**Marion County
Board of County Commissioners**

**PLANNING & ZONING SECTION
STAFF REPORT**

Public Hearing Dates	P&Z: 8/25/2025	BCC: TBD
Case Number	250706ZP	
CDP-AR	32937	
Type of Case: Rezoning	FROM: General Agriculture (A-1) TO: Planned Unit Development (PUD); Up to 300 detached SFRs (3.31 DU/AC; 83% of potential land density)	
Owner	Estate of M. Couture, L. & C. Couture, J. & J. Heaxt, and C. & V. Couture	
Developer (Owner)	Enclave Housing, LLC., Joel Rosenberg	
Applicant	Tillman & Associates Engineering, LLC.	
Street Address / Site Location	16152 and 16200 SE 73rd Avenue, Summerfield, FL 34491, or not assigned	
Parcel ID Number(s)	47667-004-00, 47667-005-02, Portion of: 47667-006-00 & 47667-003-01	
Property Size	±90.69 acres	
Future Land Use	Medium Residential (MR) [<i>Subject to approval of concurrent Small-Scale Comprehensive Plan Amendment Application 25-L04</i>]	
Zoning Classification	General Agriculture (A-1)	
Overlay Zones / Special Areas	Outside the Urban Growth Boundary (UGB) in the Rural Area outside the S. US Hwy 27/441 & SE Hwy 42 Urban Area; In the Secondary Springs Protection Overlay Zone (S-SPOZ); In Marion County Utilities SE Regional Service Area; Not in the F

Figure 7 - PUD Development Standards

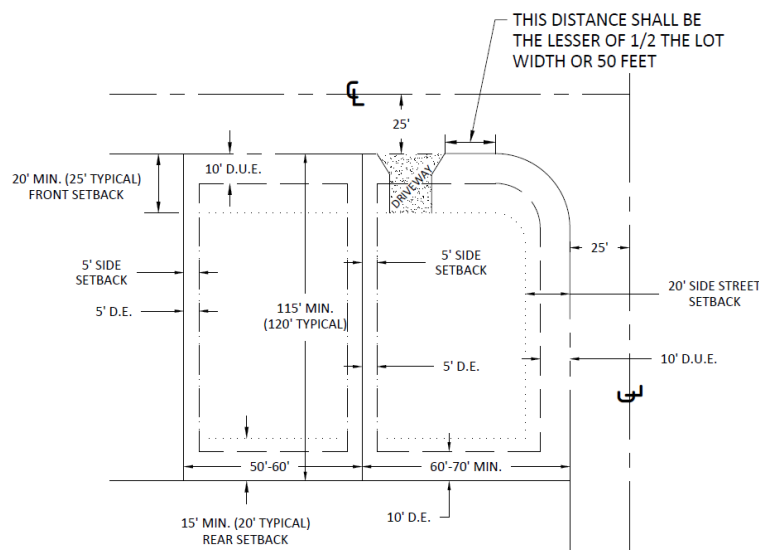
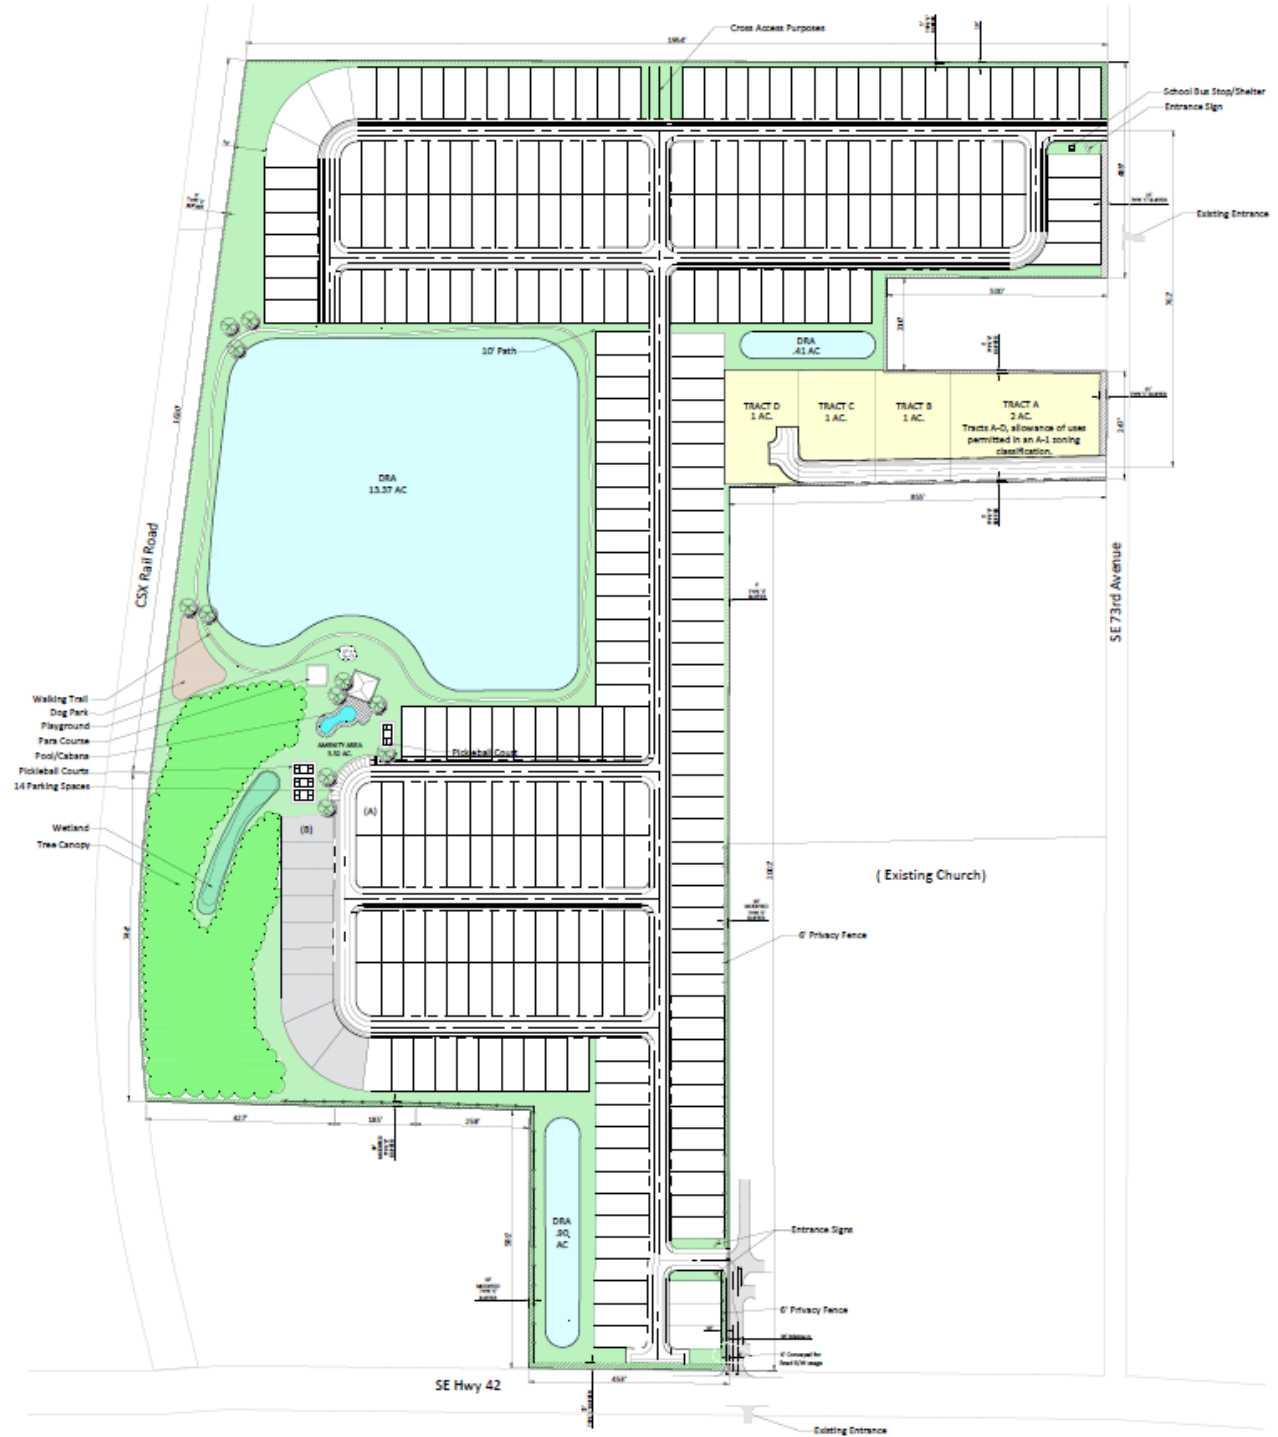
The PUD Plan's proposed development standards address allowing accessory structures as allowed in the R-1 zoning classification with enabled encroachments into primary structure setbacks. Staff notes that the LDC generally enables encroachments for non-habitable accessory structures including pool enclosures, pools, sheds, etc., but not for habitable structures or spaces, such as potential family/guest cottage/apartments, as such, ***staff recommends that accessory structures eligible for the accessory structure setbacks shall be qualified as non-habitable structures (e.g., screen enclosures, pools, pool enclosures, etc.) as provided in the R-1 zoning, except that no family/guest cottage/apartments shall be permitted.*** Staff notes that the proposed reduced minimum lot width dimensions and setbacks are similar to recent trends including the Gaekwad Village PUD's SFR area to the east that enables 40', 50' and 60' wide detached single-family lots.

A height limit of 40-feet is proposed, and that height limit is consistent with the ordinary height limit for R-1 zoning and is a lower height than that allowed on the surrounding General Agriculture (A-1) zoned properties. However, no height limit is proposed for possible accessory structures; as such ***staff recommends a 20-foot height limit for such structures also consistent with R-1 zoning.*** Additionally, LDC Section 4.2.31.E(4) references compatibility between new residential development and existing residential developments related to building heights. The proposed building heights will conform to those requirements, but will enable 2-story homes along the project's outer perimeter as the surrounding zoning is A-1 which is not classified as a residential zoning classification.

In regards to the estate lots, no specific development standards have been proposed, which would essentially require a default to the larger 60-foot wide minimum lot standard. However, the PUD proposes those lots would be subject to the standards of A-1 zoning for allowable uses. Staff has concerns regarding that proposal as the A-1 zoning does allow a significant variety of animals that may not be suited to a general 1-acre minimum site. As an alternative, ***staff recommends that for the estate lots, the uses enabled be consistent with the Residential Estate (R-E) zoning classification, along with the notation the provision that that accessory structures eligible for the accessory structure setbacks shall be qualified as non-habitable structures (e.g., screen enclosures, pools, pool enclosures, etc.) as provided in the R-1 zoning, except that no family/guest cottage/apartments shall be permitted.*** The four above conditions are reflected in Table C (underlined, green text) below:

TABLE C. PROPOSED USES, DESIGN & DEVELOPMENT STANDARDS			
STAFF RECOMMENDED ADJUSTMENTS			
Minimum Standards	Measurements (Feet or Square Feet (SF))		
Lot Type	<u>Estate Lots</u>	60' min. width Westside, south of Amenity Area	50' min. width (All other lots)

TABLE D. BUFFER COMPARISON AND RECOMMENDATION

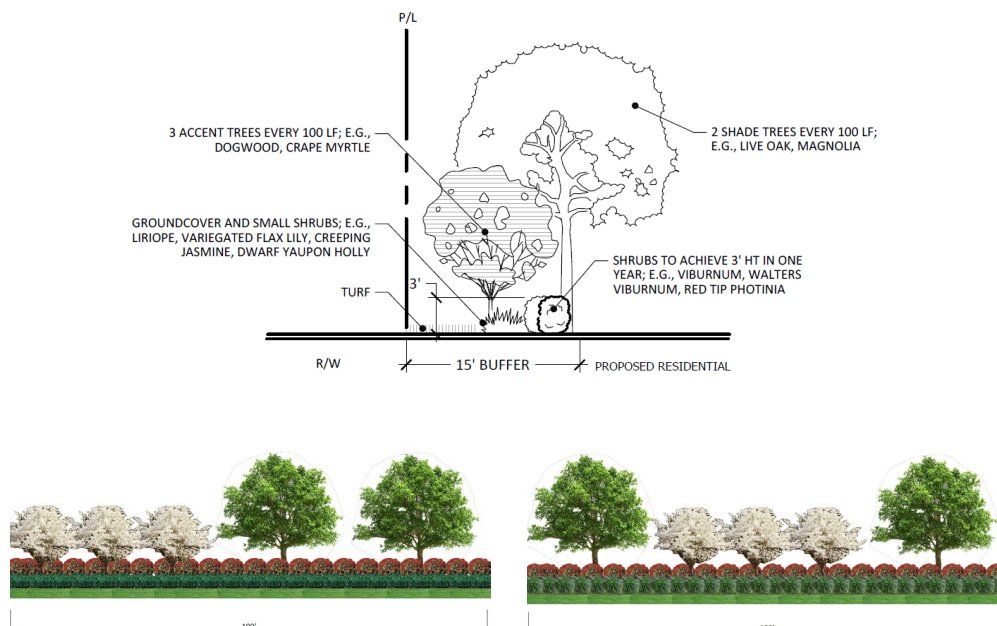
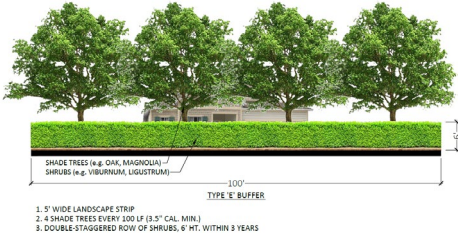
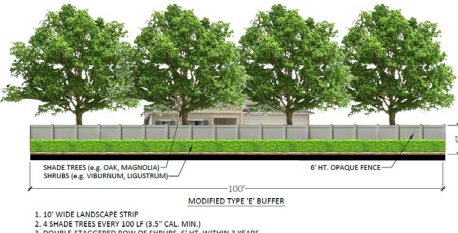
The LDC now requires land use buffers or fences between new single-family residential subdivision developments and existing single-family residential uses. However, the site adjoins a combination of agriculture properties with residences, commercial sites, and institution sites. rather than residential zoned properties, 6' high privacy fencing has been proposed, functionally consistent with the LDC. An LDC compliant Type "C" buffer is proposed along SE 73rd Avenue while an alternative Modified Type "E" Buffer is proposed along the CSX Railroad "S" Mainline right-of-way. Table D summarizes the PUD's required and proposed buffers, and *staff supports the proposed buffers as they will comply with or exceed LDC requirements, and recommends the buffers as indicated be recognized as a PUD development condition.*

Direction	Adjoining Use	Required	Proposed	Recommended
NORTH Incl. north outparcel	Ag Tract w/SFR	"E"	Type "E"	As Proposed
SOUTHWEST - West	RV/Boat Storage	"A"	No Buffer (DRA)	As Proposed
SOUTHWEST - Central	Office	"A"	Modified Type "E" increased to 10-foot wide w/internal 6-foot privacy fence	As Proposed

Direction	Adjoining Use	Required	Proposed	Recommended
SOUTHWEST - East	Ag Tract w/SFR	"E"	Modified Type "E" increased to 10-foot wide w/internal 6-foot privacy fence	As Proposed
SOUTH - East	St. Marks Church & Vet Clinic	"E"	Type "E"	As Proposed
EAST - North	SE 73rd Avenue	"C"	Type "C"	As Proposed
EAST - Central	Ag Tracts w/SFR	"E"	Type "E"	As Proposed
EAST - South	St. Marks Church & Vet Clinic	"A"	Modified Type "E" increased to 10-foot wide w/internal 6-foot privacy fence	As Proposed
WEST - North	CSX RR Mainline	"C"	Type "E"	As Proposed
WEST - South	Ag Tract w/SFR	"E"	Modified Type "E" increased to 10-foot wide w/internal 6-foot privacy fence	As Proposed
